Minute No. 389
Report – Standing Policy Committee on Property and Development – April 6, 2023

Item No. 9 **Subdivision and Rezoning – 963 Centennial Street**
(River Heights-Fort Garry Ward)
File DASZ 34/2022 [c/r DAV 151948/2022D]

Title: DASZ 34/2022 – 963 Centennial Street

Issue: For consideration at the public hearing for a rezoning to "RMF-S" Residential Multi-Family Small to permit a townhouse development (seven units).

2ND FLOOR PLAN
Not to Scale

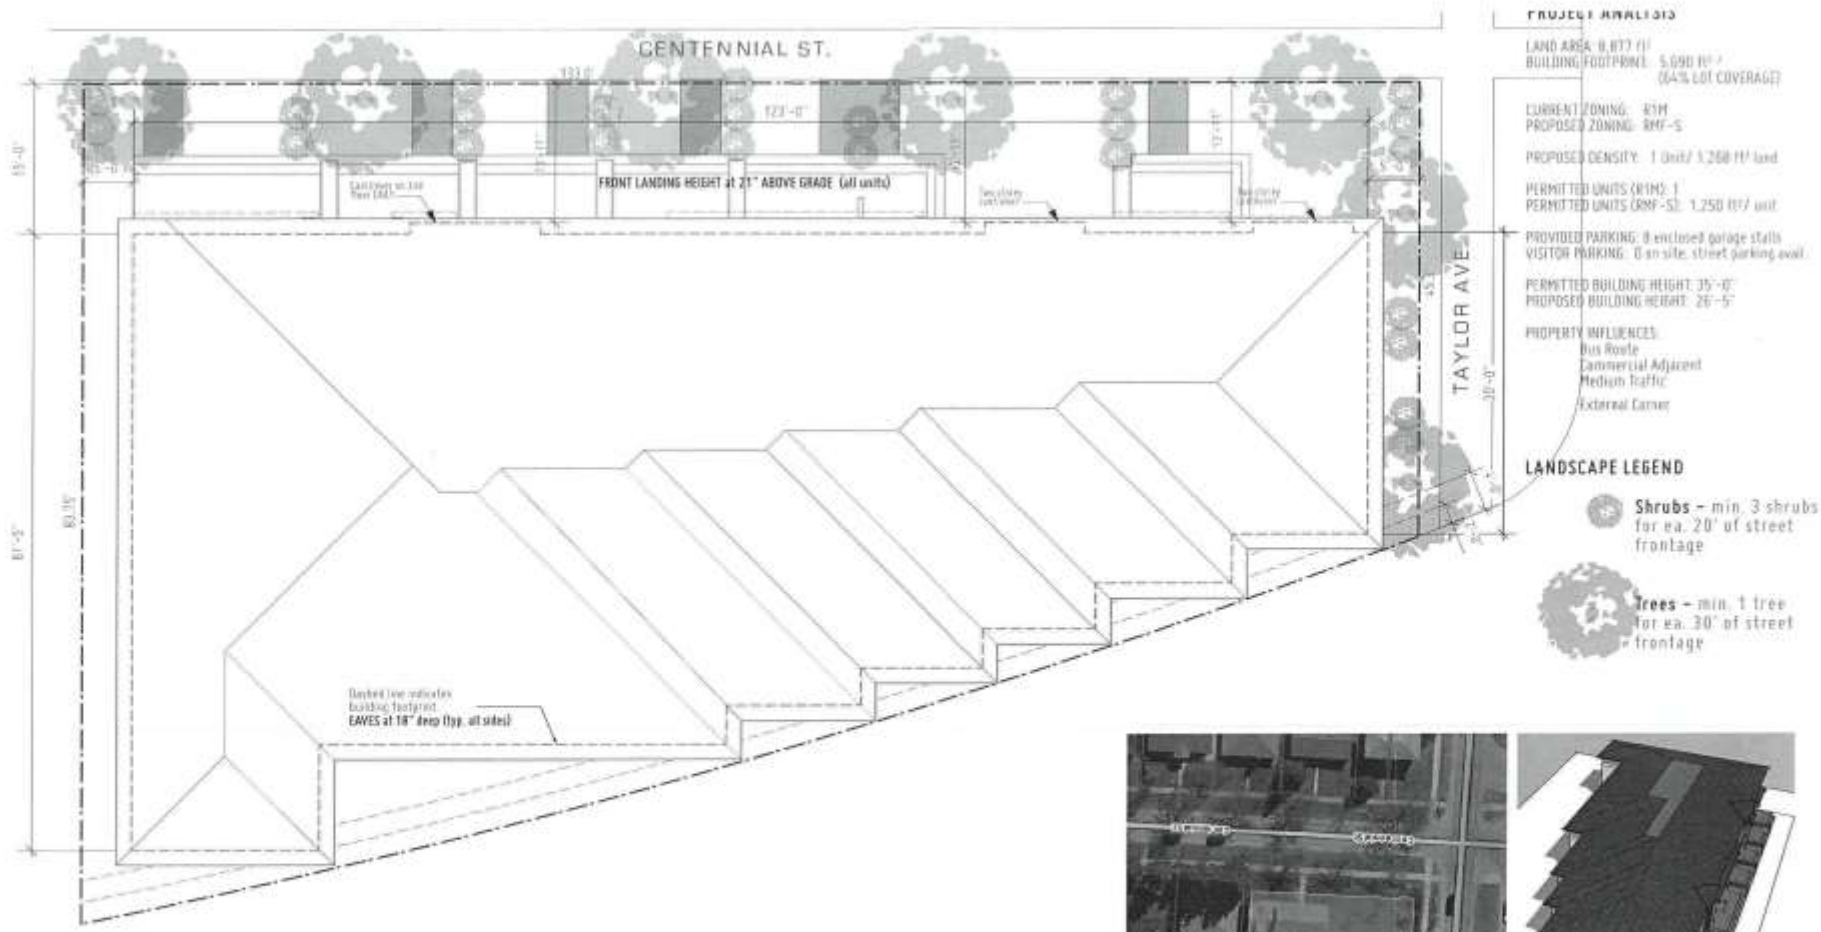
- Lot coverage: 42% permitted, 64% proposed
- Rear yard: Minimum 25 feet required, 2 feet proposed
- Front yard: 25 feet based on front yard alignment (variances permitted within 5 feet of alignment), 15 feet proposed (variance of 10 feet).

- Side yards: Minimum required side yards are 6 feet on each side, 5 feet are provided on each side.
- Corner façade condition: Required window coverage on elevation flanking Taylor Avenue is 15%, 7.2% is proposed. A unit facing the corner street is strongly encouraged.

- One-storey projections into front yard: For a stoop or porch may extend into the required front yard setback 5 feet, but not less than 10 feet from the property line. It appears they are 6-7 feet from the property line. Dimension not shown.

- Soft landscaping: Percentage of coverage is unknown. 20% is required.
- Trees: Required to be planted not less than 6.56 feet (2.0 metres) from a public sidewalk, a minimum of 3.28 feet (1.0 metres) from a property line, and should be located at a sufficient distance from the dwelling to allow for full canopy and root system development. The proposed trees appear to be shown less than 5 feet from sidewalks on Centennial Street and Taylor Avenue.

The plans show major inconsistencies with the design guidelines and as such, a context-sensitive townhouse development has not been demonstrated at this time.
